FORM APPROVED  
OMB NO. 1004-0137  
Expires: January 31, 2018**SUNDRY NOTICES AND REPORTS ON WELLS**  
*Do not use this form for proposals to drill or to re-enter an abandoned well. Use form 3160-3 (APD) for such proposals.*5. Lease Serial No.  
NMNM012121

7. If Unit or CA/Agreement, Name and/or No.  
891005247F8. Well Name and No.  
COTTON DRAW UNIT 119H9. API Well No.  
30-015-37447-00-S110. Field and Pool or Exploratory Area  
POKER LAKE11. County or Parish, State  
EDDY COUNTY, NM**SUBMIT IN TRIPLICATE - Other instructions on page 2**

**Permanent Abandonment of Federal Wells  
Conditions of Approval (LPC Habitat)**

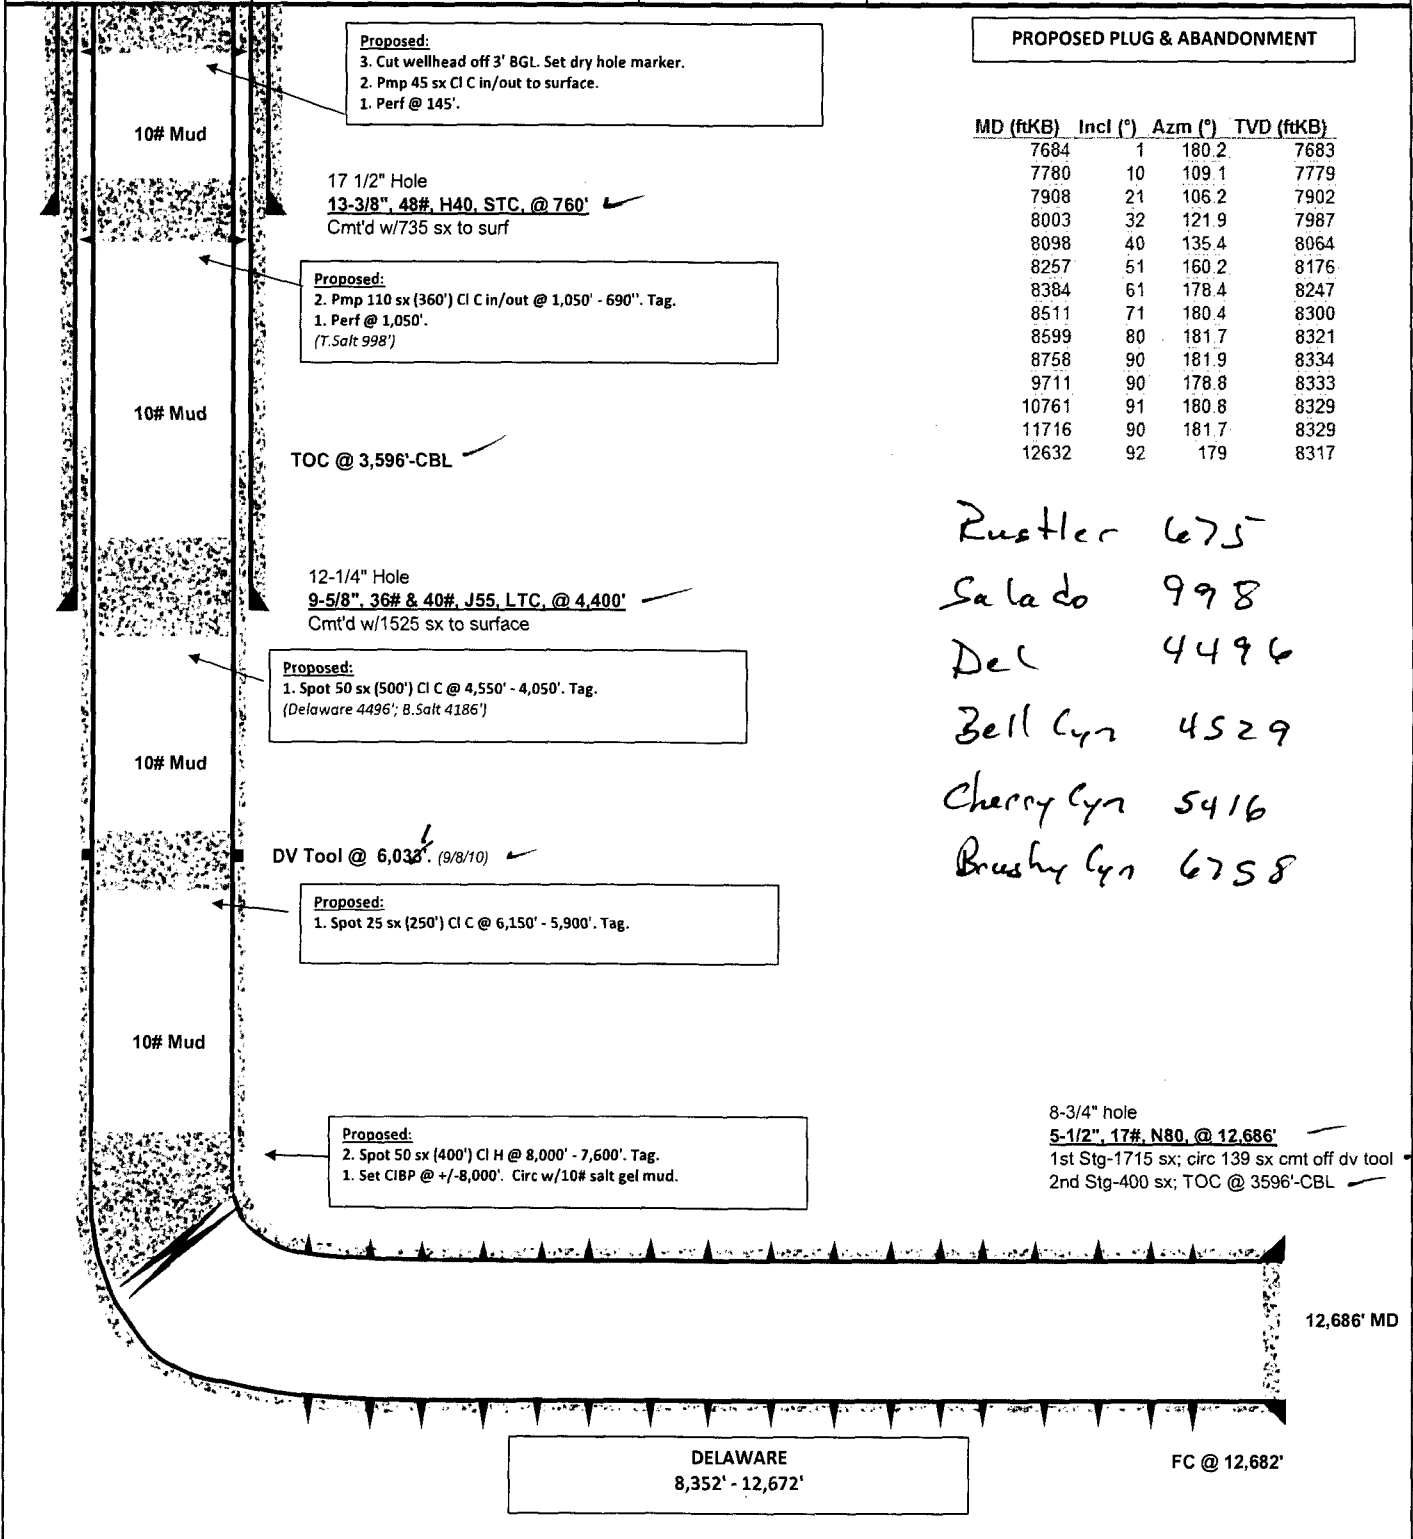
- MIRU P&A unit.
- POOH w/2-7/8" production tubing and ESP pump assembly from 7,828.
- Set CIBP @ +/-8,000'. Circulate wellbore w/10# salt gel mud.
- Spot 50 sx (400') Cl H @ 8,000' - 7,600'. Tag.
- Spot 25 sx (250') Cl C @ 6,150' - 5,900'. Tag. (dv tool @ 6033')
- Spot 50 sx (500') Cl C @ 4,550' - 4,050'. (t.delaware 4496'; 9-5/8 shoe 4400'; b.salt 4186')
- Perf 5-1/2" @ 1,050'.
- Pump 110 sx (360') Cl C in/out @ 1,050' - 690'. Tag. (t.salt 998'; 13-3/8 shoe 760')
- Perf 5-1/2" @ 145'.
- Pump 45 sx Cl C in/out to surface.
- Cut wellhead off 3' BGL. Set dry hole marker.

SEE ATTACHED FOR  
CONDITIONS OF APPROVALRECLAMATION PROCEDURE  
ATTACHEDSC 1-31-18  
Accepted for record - NMOC*Below ground level dry hole marker required*
